FINAL  
ENVIRONMENTAL STATEMENT  
Related to the Proposed  
SEABROOK STATION  
Units 1 and 2

**UNITED STATES ATOMIC ENERGY COMMISSION**

**Date Issued: DECEMBER 1974**

5. The following Federal, State, and local agencies were asked to comment on the Draft Environmental Statement issued in April 1974.

Fig. 2.3. Land use plan. Source: ER, Sect. 2.1, Fig. 2.1-4.

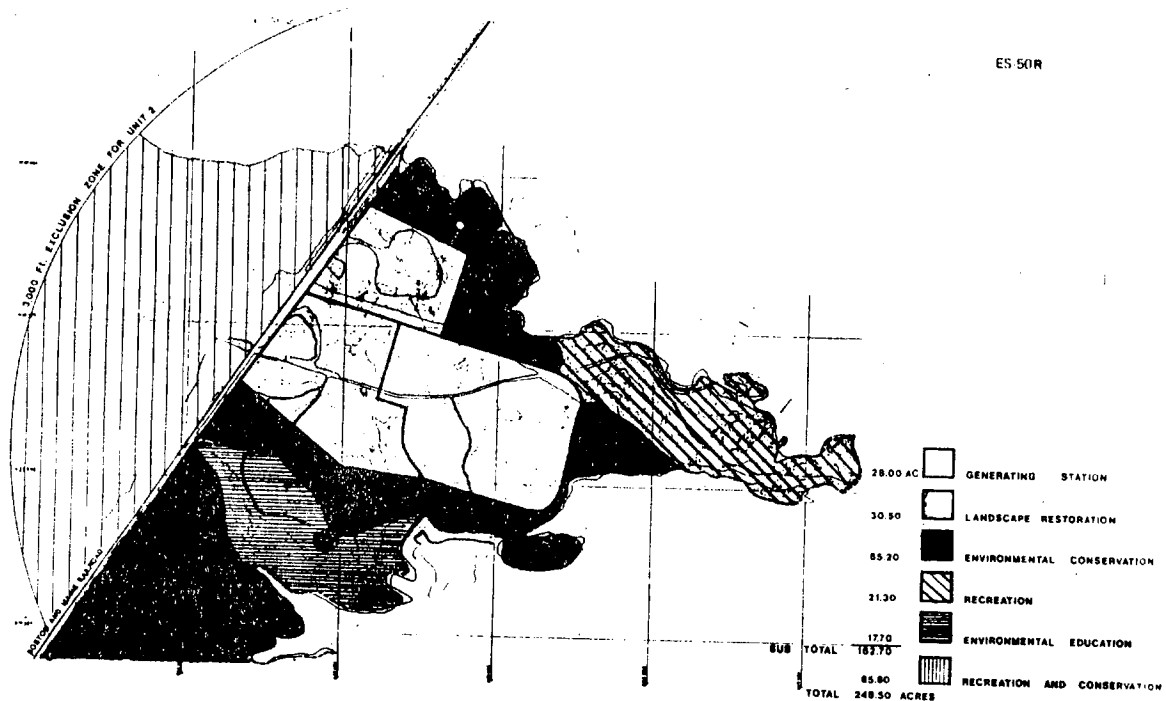
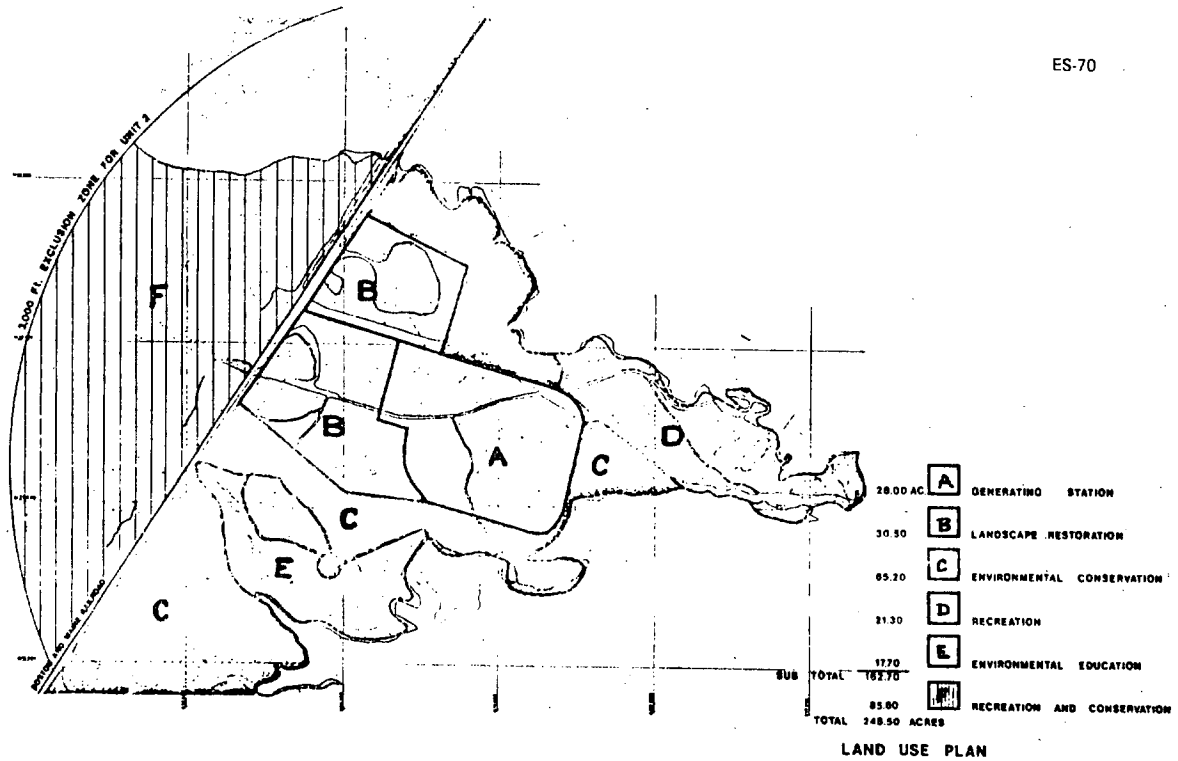
Of primary interest to us are the applicant's plans regarding use of lands and associated water under its control not needed for power generation and ancillary facilities. A land use plan is represented by figures 2.3 and 4.1, but these drawings do not include any discussion of that plan. By their inclusion in the draft environmental statement, figures 2.3 and 4.1 imply a commitment by the applicant of roughly 190 acres of its land holdings to public recreation or other public use activities. To clarify this matter, we suggest that the final environmental statement include a thorough discussion of the applicant's contract study entitled, "Land Planning and Site Design Study," conducted by KLING/PLANNING (Appendix I of the environmental report). The discussion should include such matters as:

Fig. 3.3. Plant water use diagram. Source: ER, Sect. 3.3, Fig. 3.3-1.

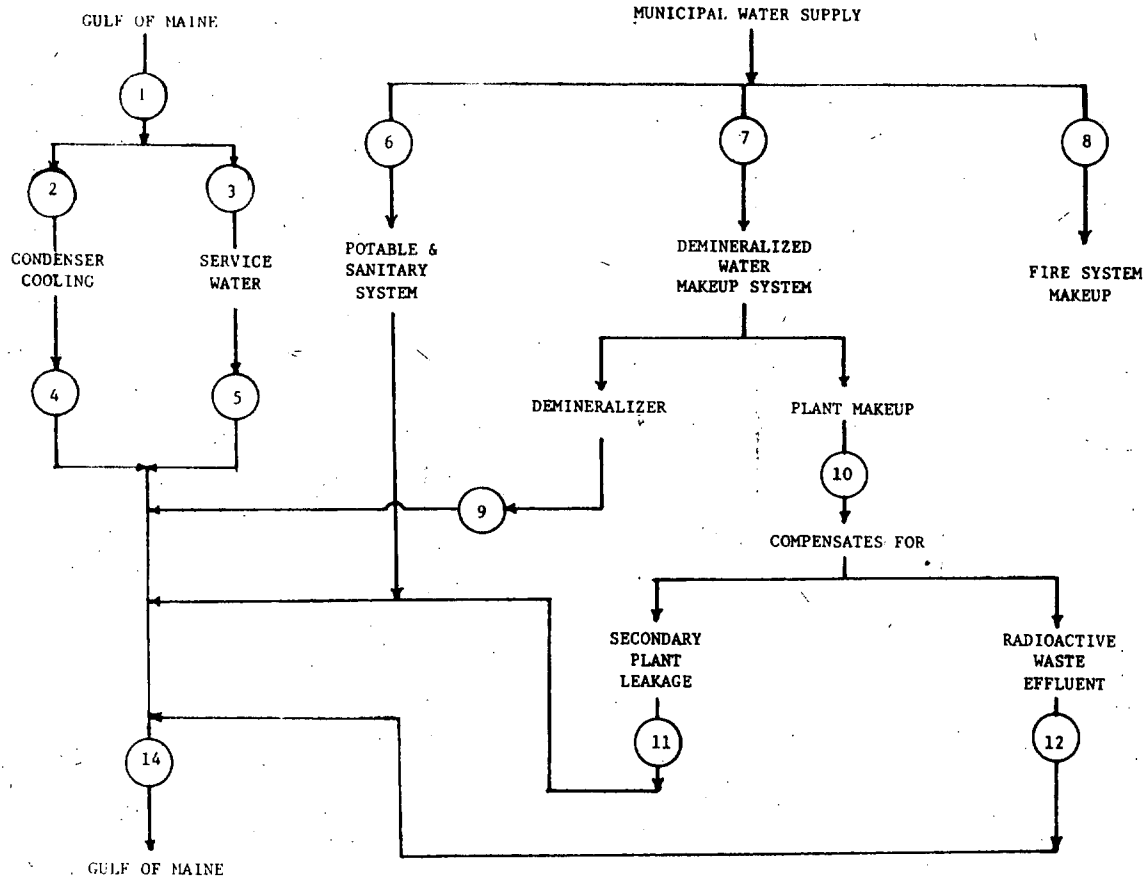
Attention is directed to revised information in Environmental Report: Section 3.3-1 which revises Draft Environmental Statement Figure 3.3. The information is repeated below for convenience. Secondary plant leakage is directed through an oil separator before going to the circulating water discharge.

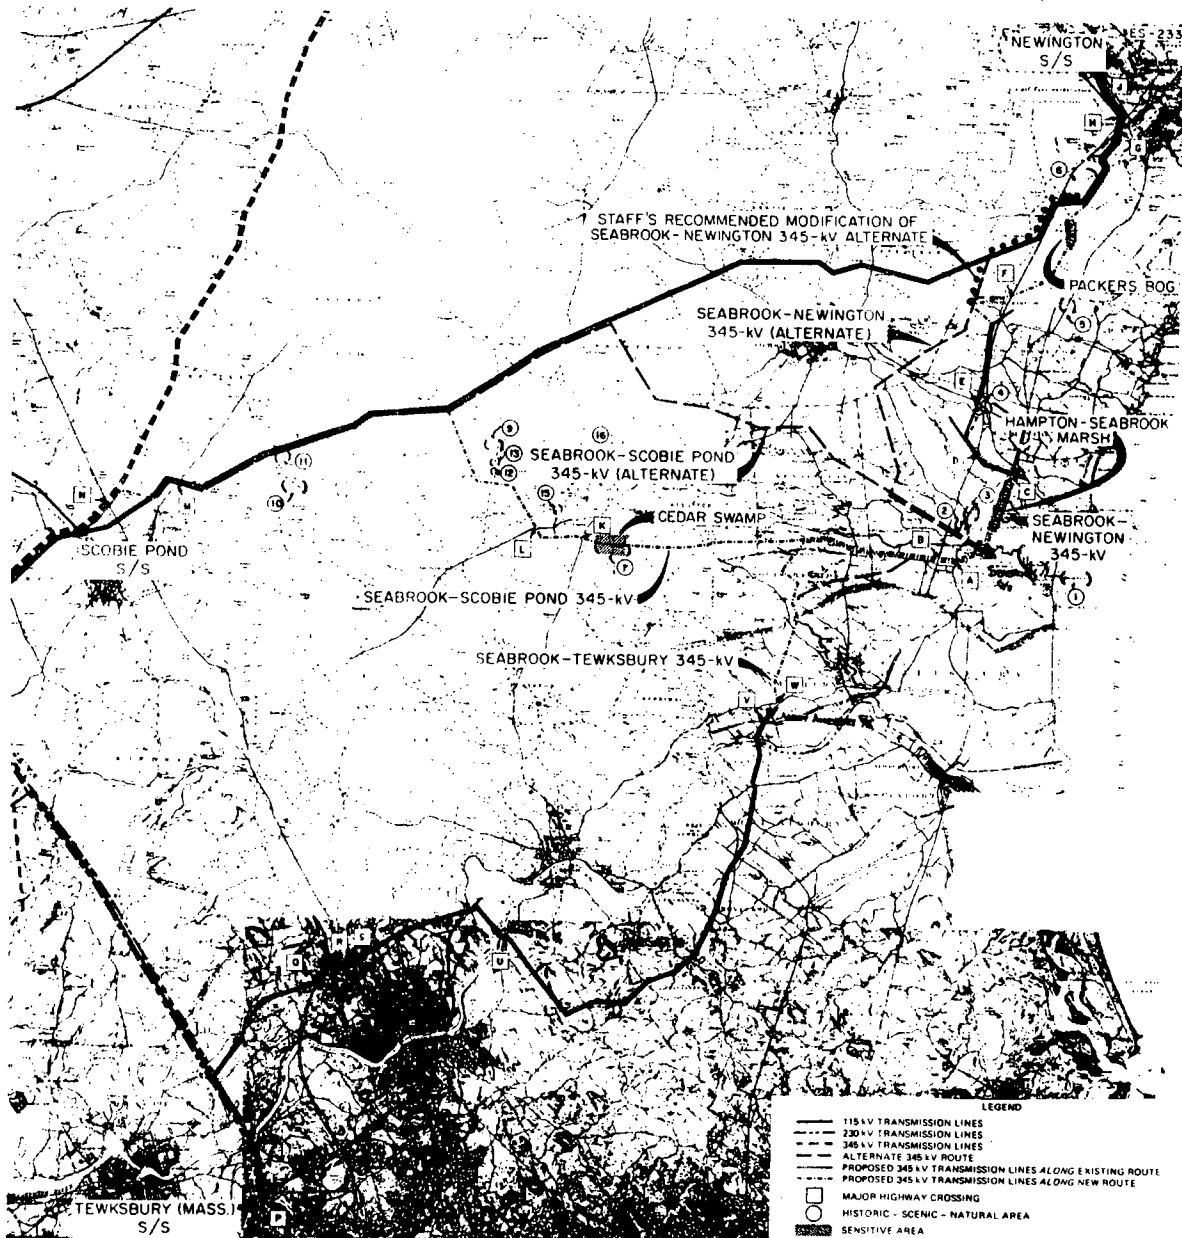
It is unclear whether the "transmission additions" noted in Figure 3.15, Page 3-31 of the DES are in addition to the initial lines proposed for Seabrook 1 and 2. The matter should be clarified for two reasons:

The staff considers that successful location of Seabrook lines along alternate routes as presented in Fig. 3.15 can be effected through careful and thoughtful right-of-way planning and utilization of environmentally acceptable clearing and facilities construction practices. Notwithstanding other possible conflicts as may arise, the staff considers preservation of the integrity of the Cedar Swamp natural area, in concert with removal of any threat of construction of overhead transmission lines across sections of the Hampton-Seabrook marsh, sufficient compensation for any additional costs likely to be incurred in implementing required alternatives.

Fig. 5.3. Summary of chlorine toxicity data on marine life.

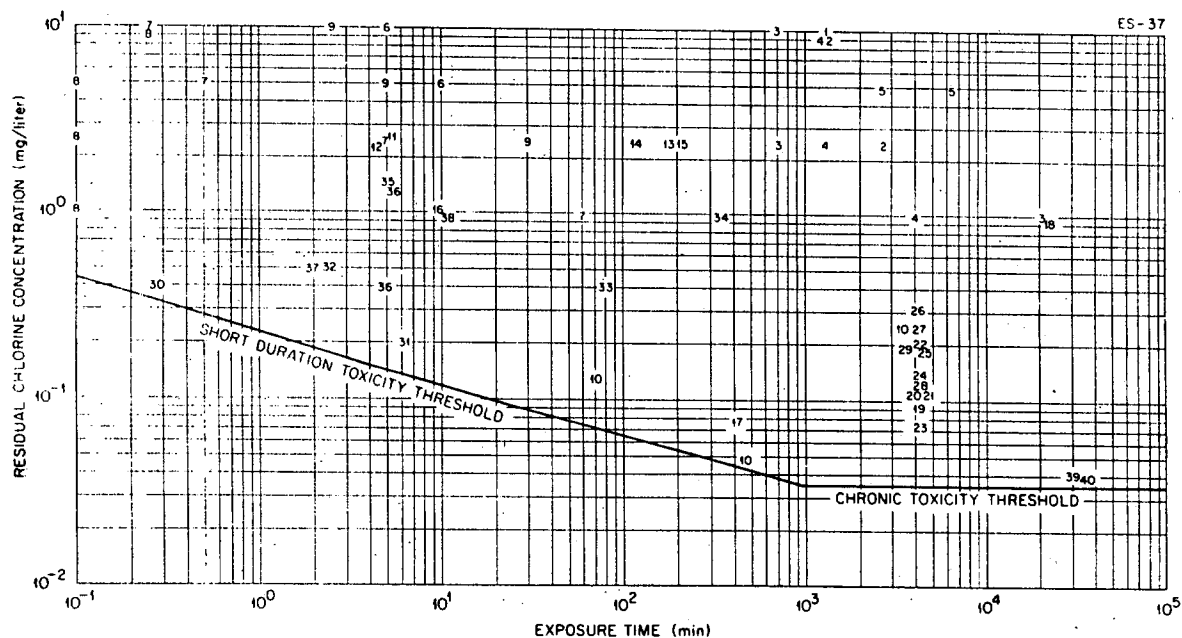
The Applicant notes that the form of the chlorine has not been expressed in this part. The Applicant suggests that all chlorine concentrations be expressed in mg/l as hypochlorous acid for free available residual chlorine. Otherwise, the possibility of confusion and misinterpretation exists over the values of concentration. This comment applies especially to Figure 5.3 and Table 5.9.

Fig. 8.3. Historic and predicted annual peak demands for the New England Power Pool.

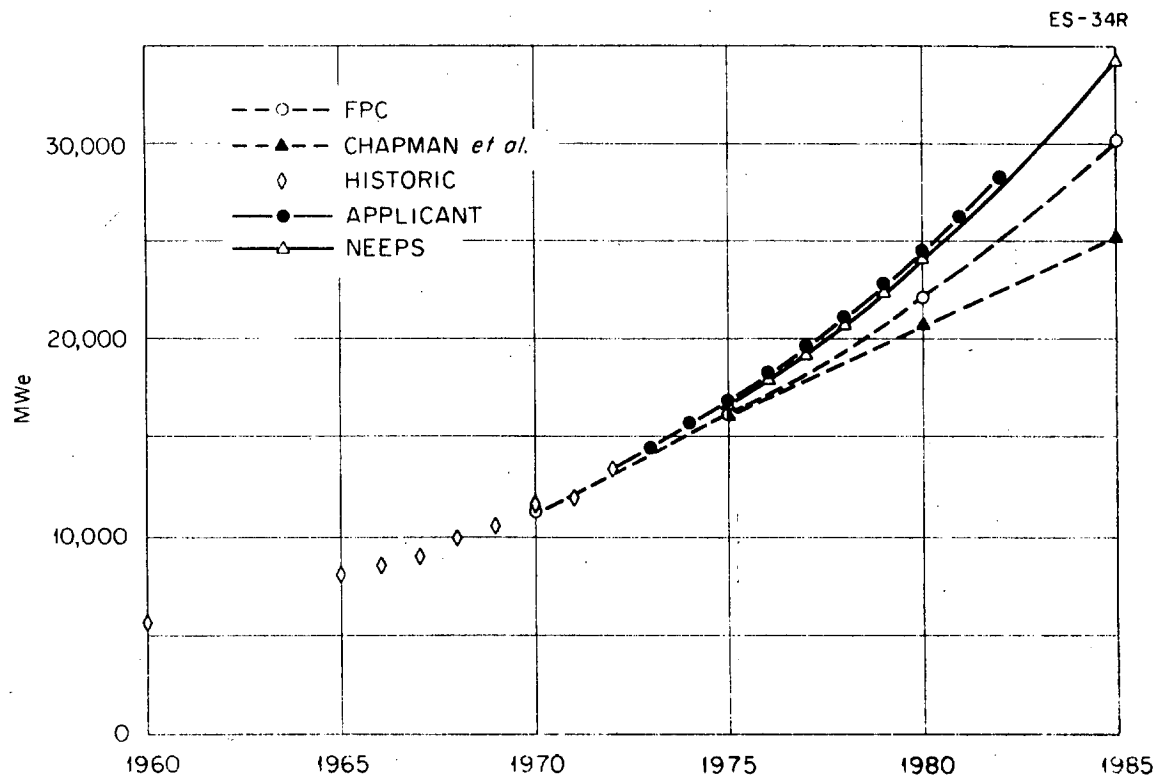
Without attempting to give any indication of the validity of the low side projection of annual peak demands for NEPOOL set forth on Figure 8.3, Public Service records that it seriously questions the validity of using electricity demand projections by Chapman, Tyrell and Mount as a proper basis for New England energy forecasting. It is our observation that elasticity studies prepared by these authors are based on questionable assumptions and data, and that use of these studies may lead to incorrect conclusions and public policy.

The draft EIS does go so far as to illustrate this point in figure 8.3. However, that figure cannot be regarded as a projection which accounts for the price effects since we don't know what price changes are incorporated therein; it is merely an illustration of the direction of the effect, not the magnitude.

Fig. 9.3. Transmission line alternate route No. 2. Source: ER, Fig. 10.9.2.

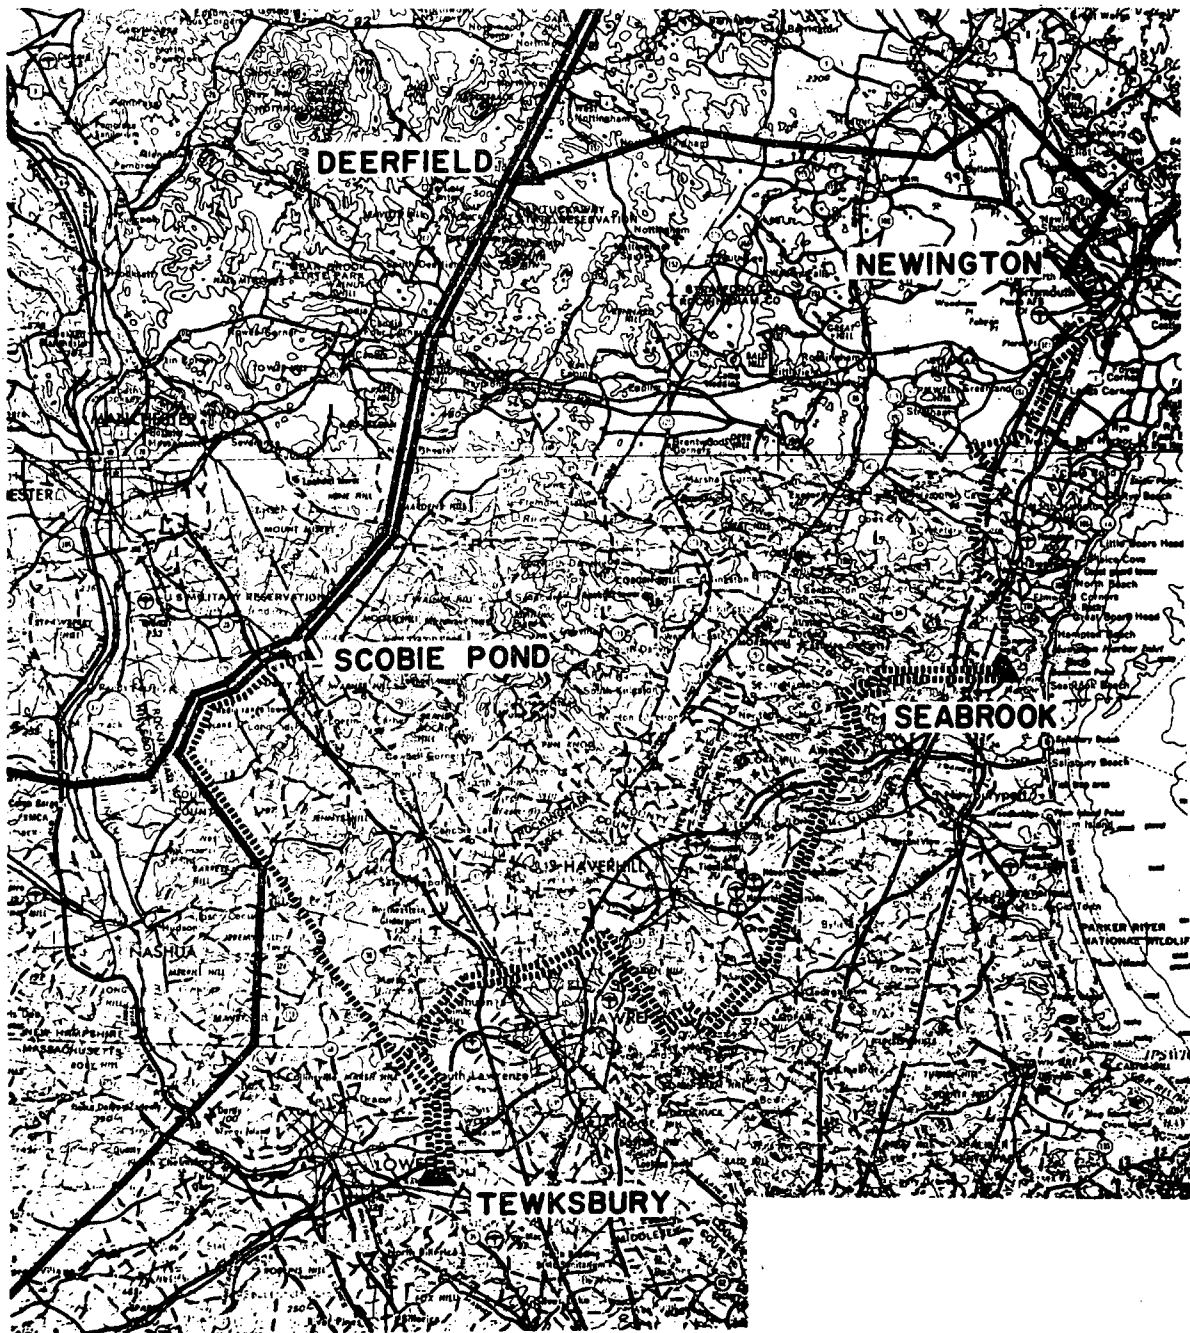
Stability studies show that the transmission system route recommended by the Staff and shown in Figure 9.3 of the Draft Environmental Statement for Seabrook Station Units 1 and 2 has an extremely detrimental effect on system reliability. If this routing is required the line cannot be terminated at Tewksbury as first proposed, since additional studies indicate that the line must be continued to Sandy Pond Substation at Ayer, Massachusetts. Figure A4.1-2 shows the additional line. The alternate route requested by the Staff will now require approximately 35 miles of additional 345 KV transmission line.

Fig. 11.5. Power-producing capacity existing and planned by Public Service Company of New Hampshire.

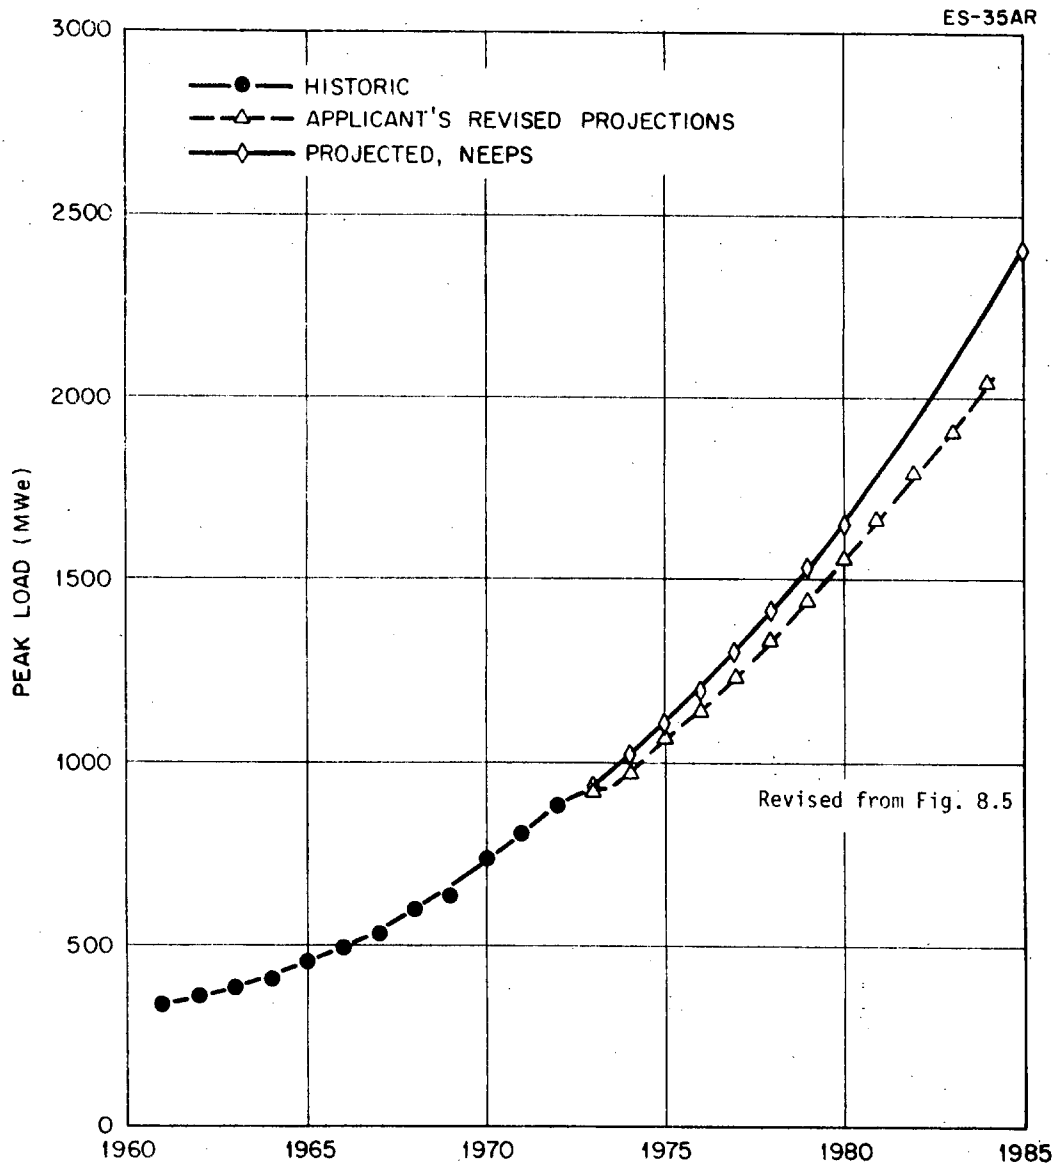
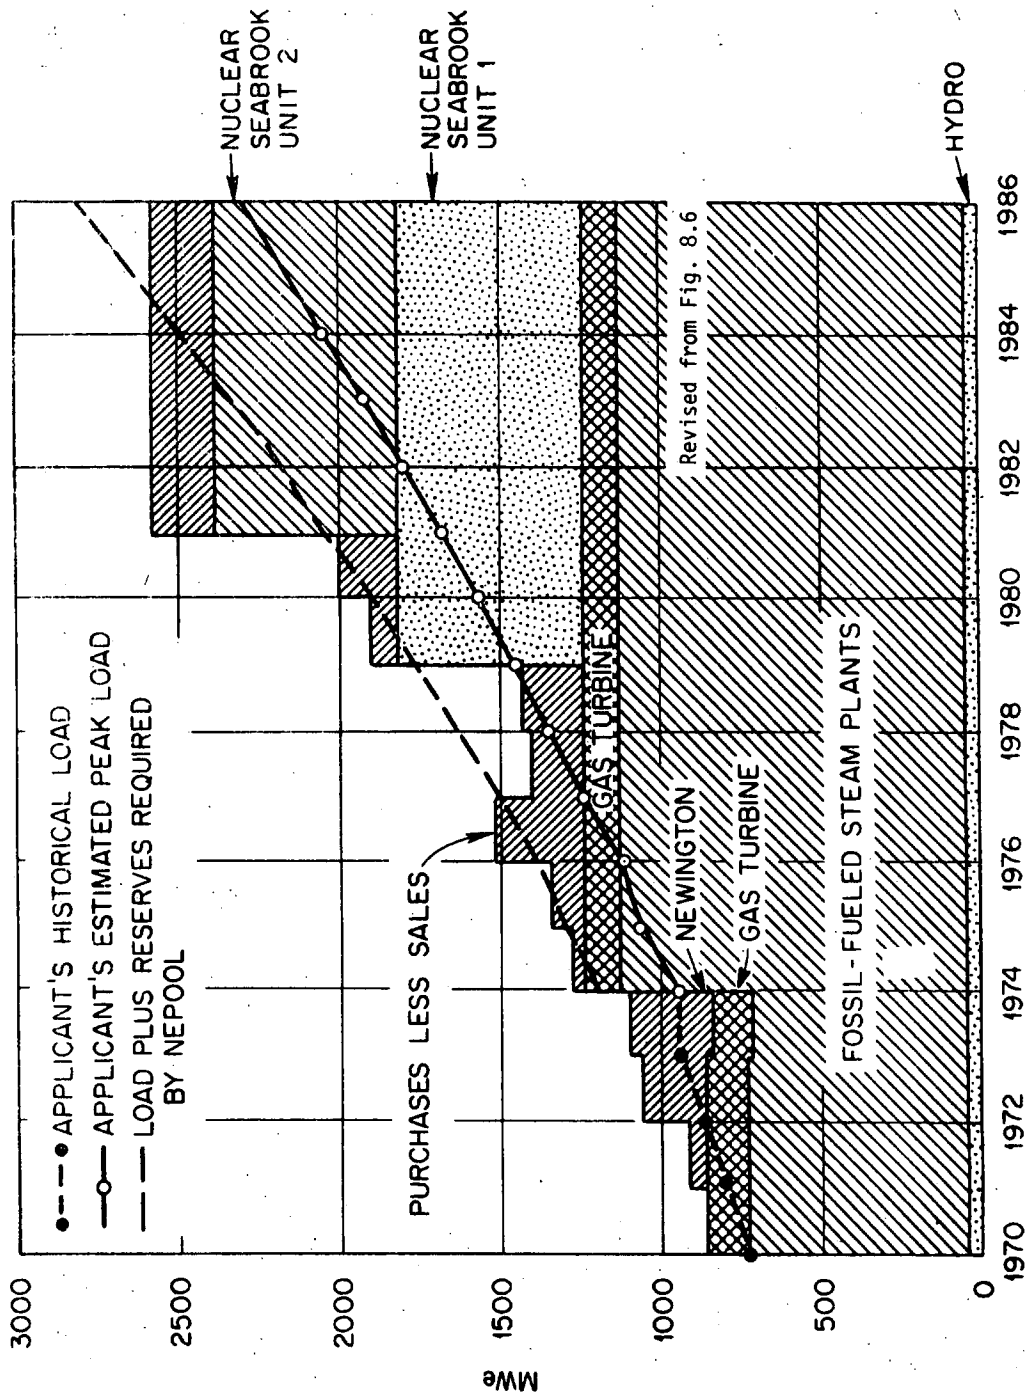
This submittal included a summary of the applicant's peak load and energy output as forecast by the applicant in August 1974. These projections are included on Figures 11.4, and 11.5, which are revisions of Figures 8.5 and 8.6, respectively. The applicant's revised predictions indicate a much lower projected peak demand than that forecast earlier. The excess of purchases over sales has also been significantly reduced for the period 1977-1979. The applicant's new projected reserve margins (including Seabrook Units 1 and 2) for 1975 through 1982 are given below (from Table II of applicant's submission) with the earlier projections in parentheses:

The revised projections given in Figure 11.5 indicate some doubt about the need for Seabrook Unit 2 in 1981 based on projections alone. The projections tend to show that the initial power from Unit 2 might not be needed by the applicant until about 1984, (2 - 3 years after the original schedule date).
